**PD Modification Application:** PRS 22-0357

**1.0 APPLICATION SUMMARY**

8.0 SITE PLANS (FULL)

## AGENCY REVIEW COMMENT SHEET

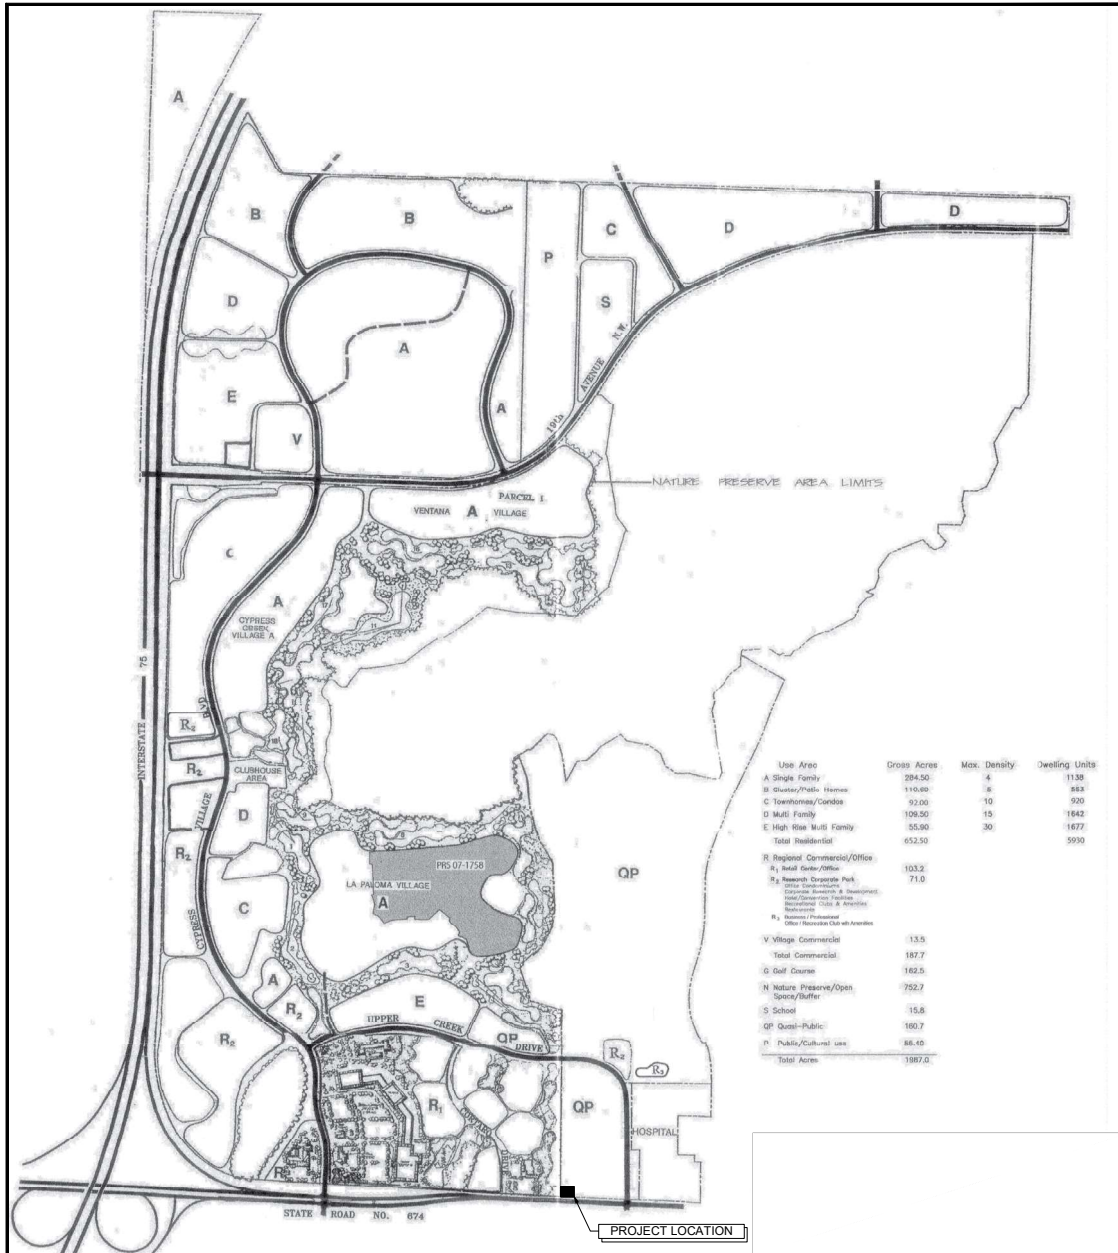
3. Access would be very minimal; as maintenance requires.
4. Shared access with TECO driveway to the east would be preferred, but if unable to achieve this, FDOT will allow a driveway to be constructed similar to what is shown in proposed plan.

5. Driveway will need to have a minimum throat depth of 16' wide and a radial design with minimum of 35' radii on both ingress and egress.
6. No pavement striping or signing will need to be added or changed.

7. A double pipe culvert may be necessary. Drainage will review required design.
8. Provide existing and proposed drainage basin maps and a narrative for the work being proposed.

9. Demonstrate that the proposed runoff does not exceed the existing runoff volume.
10. Complete the attached exemption questionnaire and submit it with the permit application.

11. This will require a category "A" access permit (if less than 20 daily trips are anticipated).
12. Will need to obtain an outdoor advertising permit with the Department and/or provide a copy of the existing settlement agreement with application.
